HISTORIC LANDMARK COMMISSION
APPLICATION FOR A CERTIFICATE OF APPROPRIATENESS
AUGUST 7, 2024
HR-2024-075431
ALDRIDGE PLACE HISTORIC DISTRICT
203 WEST 32ND STREET

PROPOSAL

Convert garage to conditioned space and replace garage door with salvaged window.

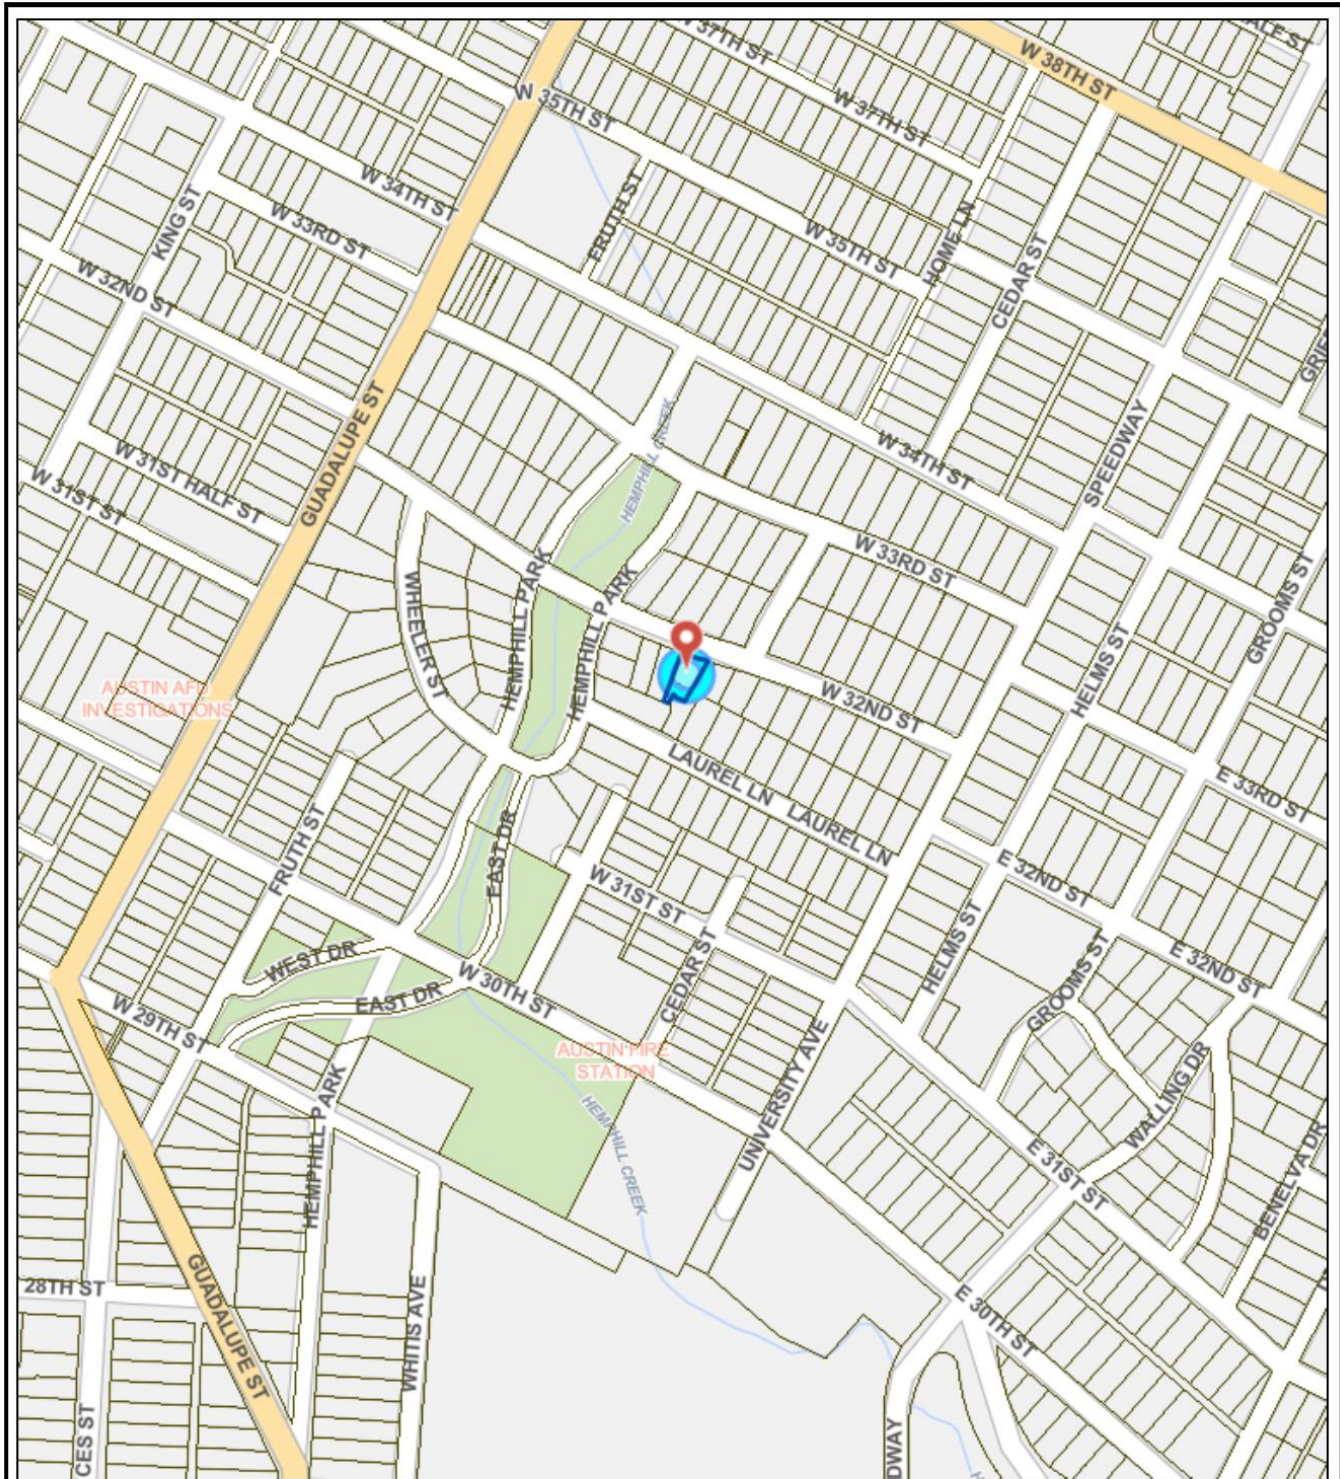
The proposal replaces the garage door with a window in the same location. The infill proposed to supplement the difference in opening size matches the surrounding wall.

Proposed infill window has been salvaged from within the historic district, from the same or similar manufacturer that created the two windows on the main floor of this property.

The proposed infill retains the driveway that presently terminates at the garage. By placing an addition to conditioned space within the building footprint, no addition is proposed. However, this alteration does affect the appearance of the house from the primary elevation, and changes one of the primary means of entering the house to longer being functional. While the infill window is below grade when viewed from one side of the property, it is at grade from the opposite due to the lot's slope.

The project meets the applicable standards.

Approve the application.
